"HIGH PINES PATIO HOMES PHASE 2E" SITE DEVELOPMENT PLAN AND AS-BUILT EXHIBIT

1404, 1432 AND 1446 PINEY HILL POINT, EL PASO COUNTY, COLORADO

SITE DEVELOPMENT PLAN AND AS-BUILT EXHIBIT
"HIGH PINES PATIO HOMES PHASE 2E" - A PORTION OF THE NE4 OF SECTION 2, TOWNSHIP 11 SOUTH, RANGE 67 WEST OF THE 6TH P.M., EL PASO COUNTY, COLORADO

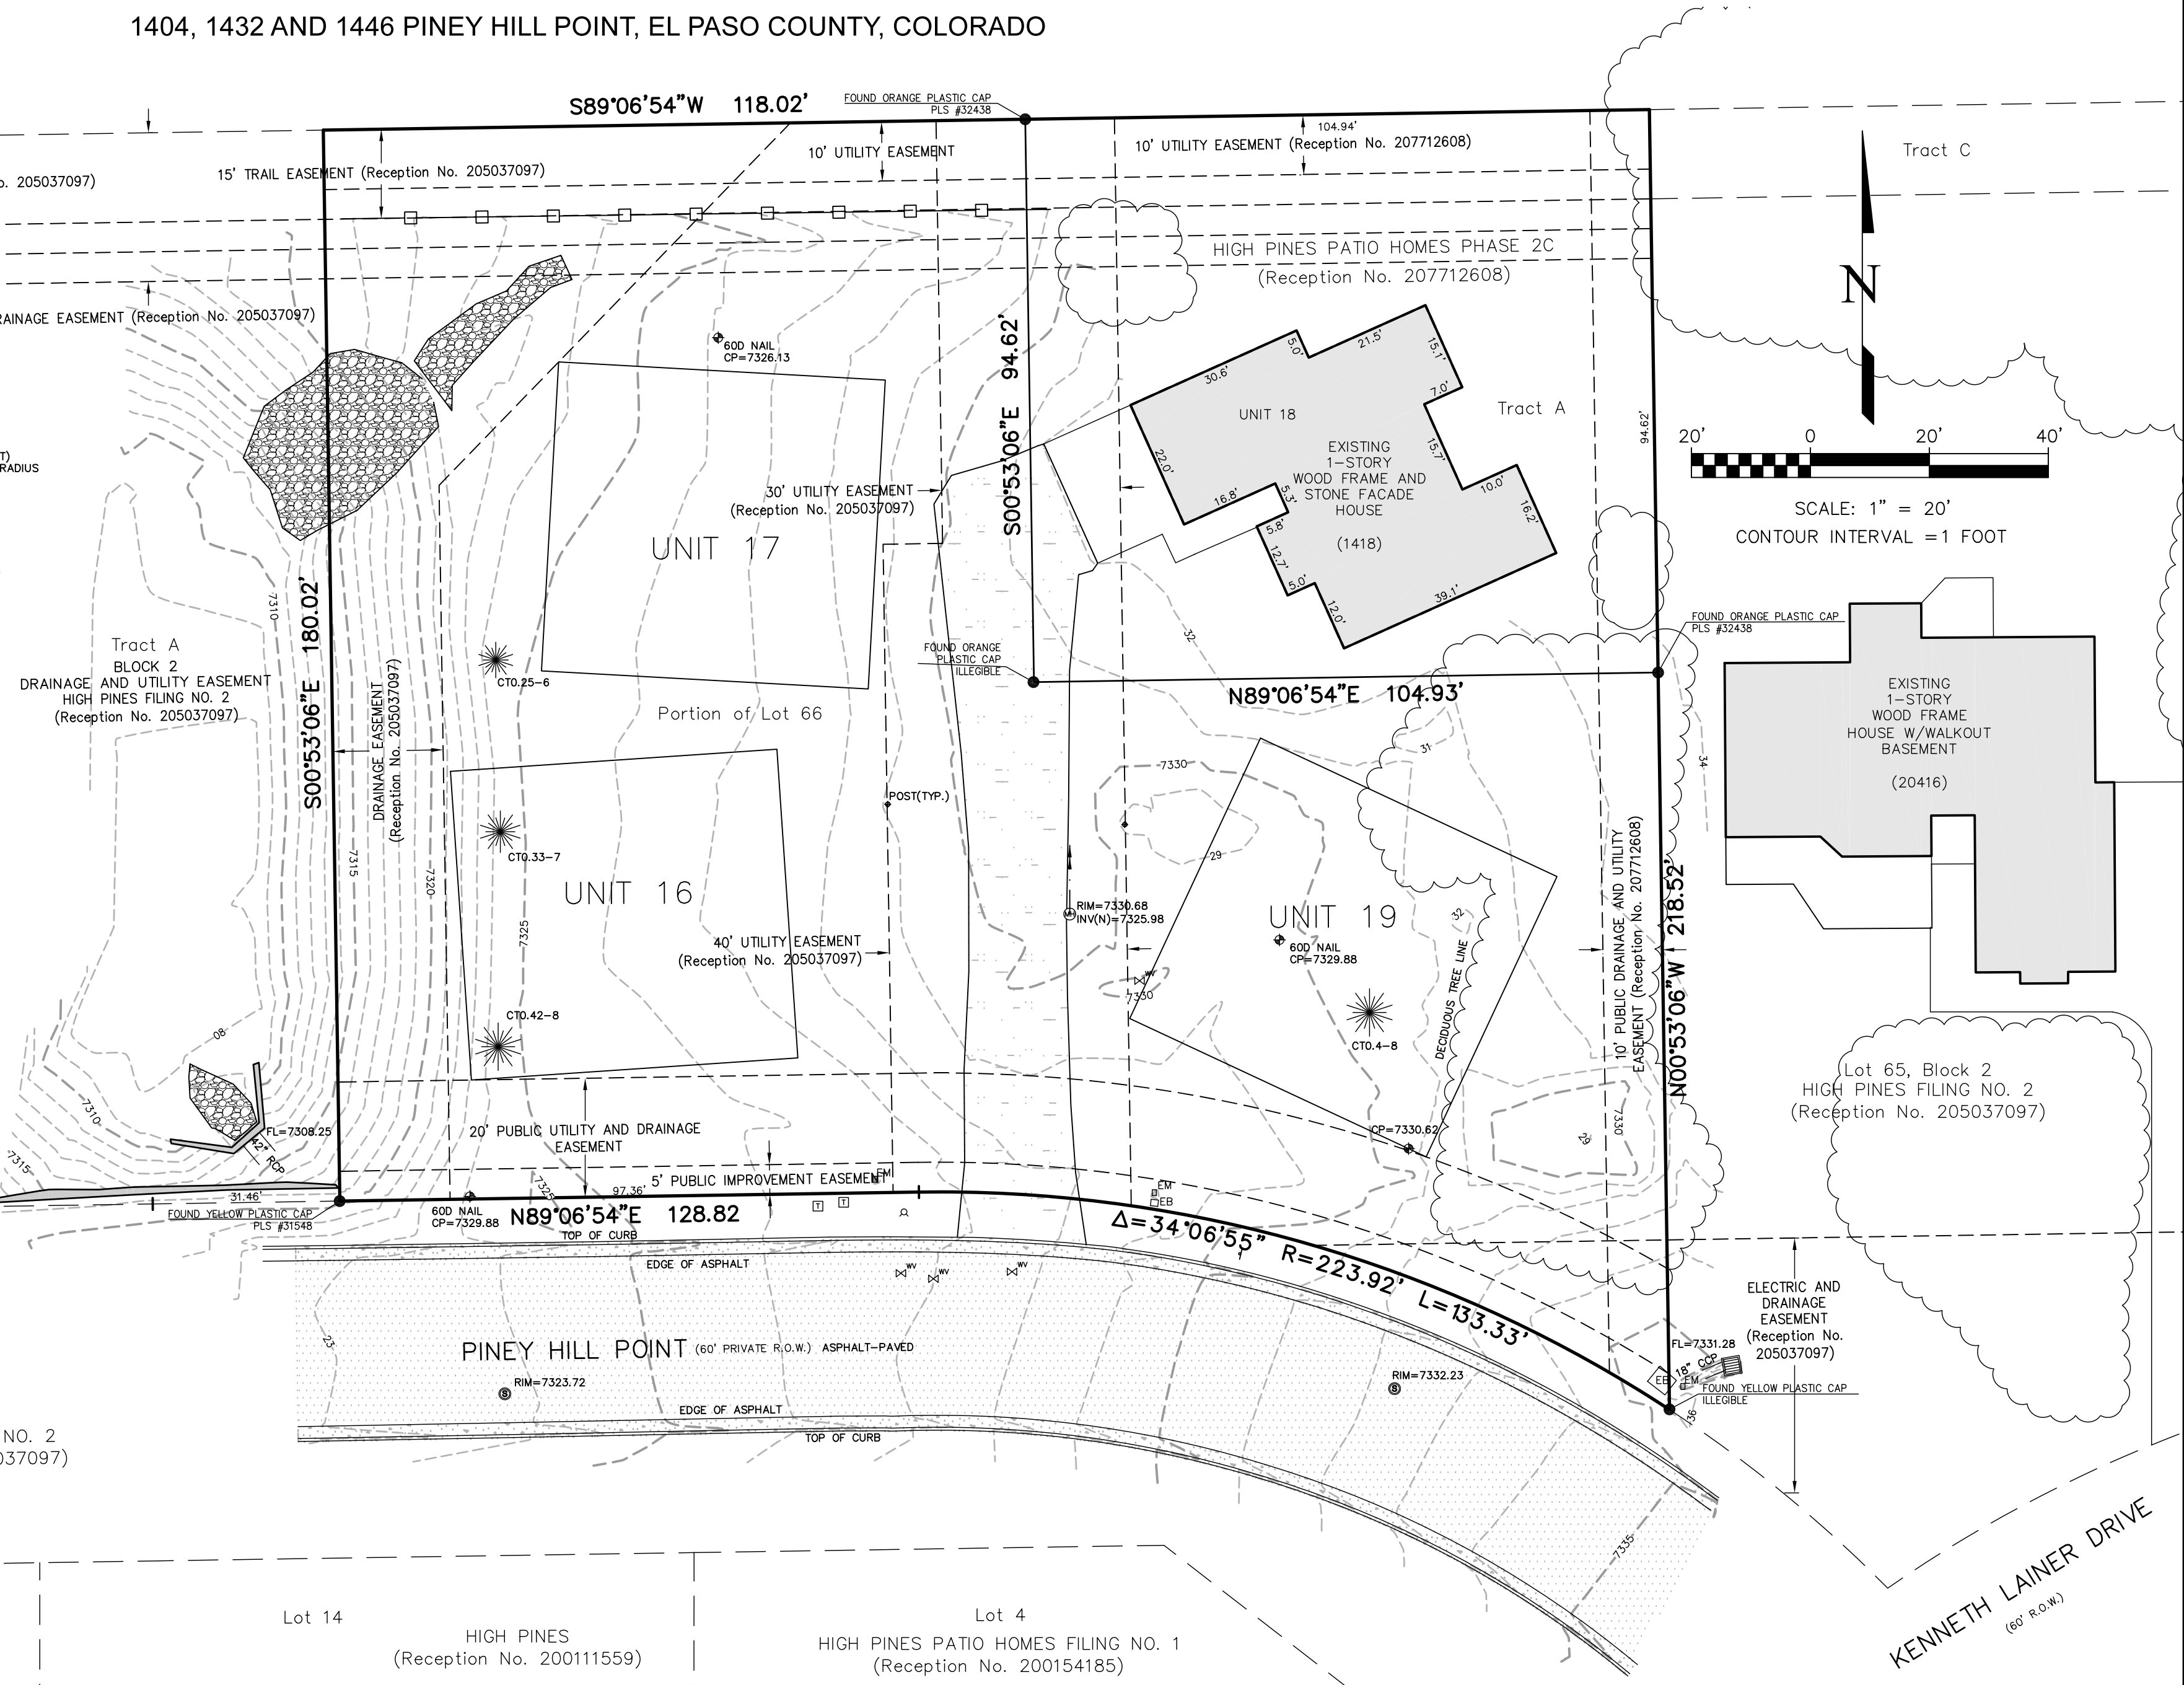
THE ATTACHED "HIGH PINES PATIO HOMES PHASE 2E" SITE DEVELOPMENT PLAN/AS-BUILT EXHIBIT WAS APPROVED BY THE EL PASO COUNTY DEVEL. You do not need to include this signature block. _____ 20 ____ A.D.
You can just include a box for the PCD Director to place his approval stamp.
DEVELOPMENT SERVICES DIRECTOR
PCD File No. PPR-2231
EL PASO COUNTY FILE NO. _____

"PRELIMINARY COF" Please remove this note.
SUBJECT TO COUNTY APPROVAL
